Meshreen Technology Ltd.

Due to the business consideration, we hereby declare that our product of JN5168 High Power ZigBee Module with u-FL connector/JN5168 Hight Power ZigBee Module with embedded antenna

Model: MS5168-M04 have as following difference

Serial model MS5168-M05 are identical with main model and the difference is :

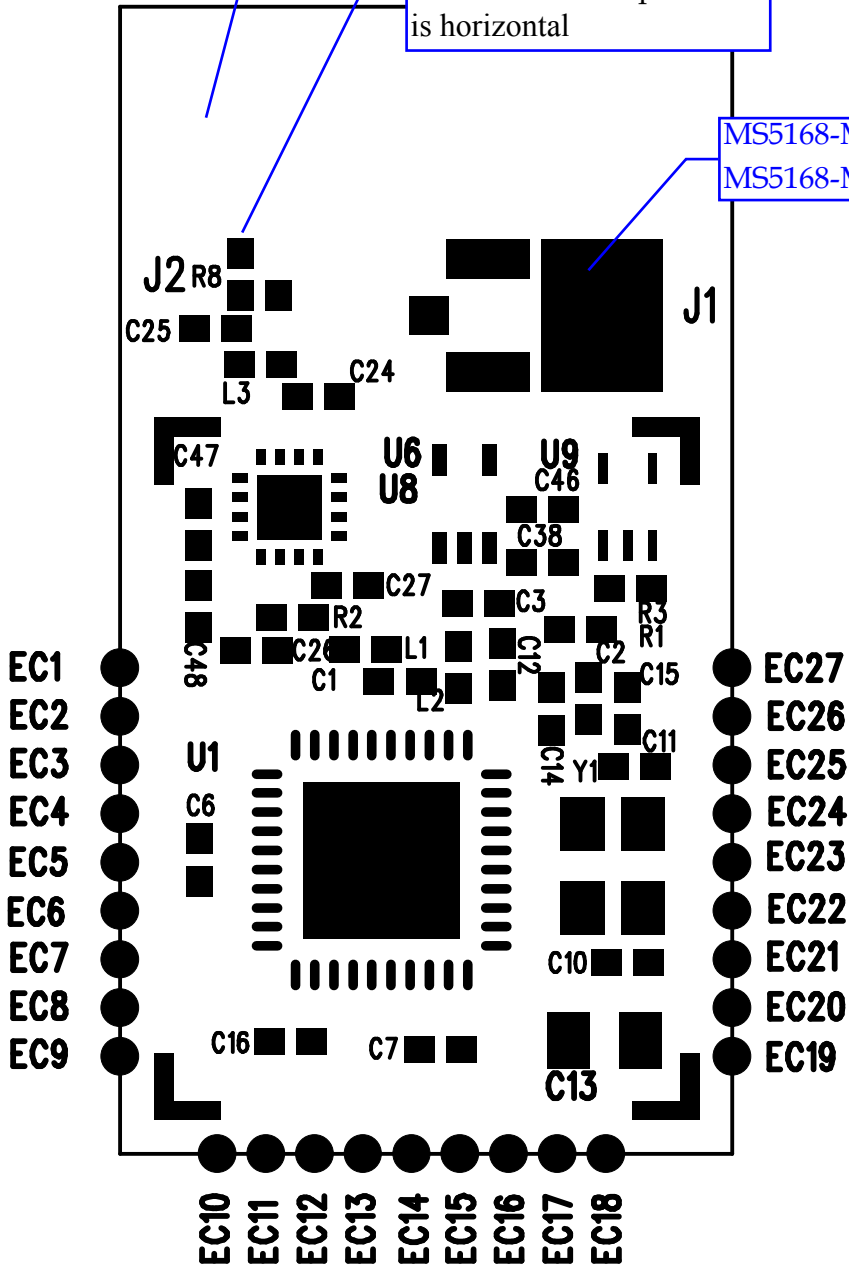
MS5168-M05: with PCB antenna
MS5168-M04: use external antenna with
J1 u-FL connector

MS5168-M04:R8 position
is vertical.
MS5168-M04:R8 position
is horizontal

MS5168-M04: J1 is not included.
MS5168-M04: J1 is included.
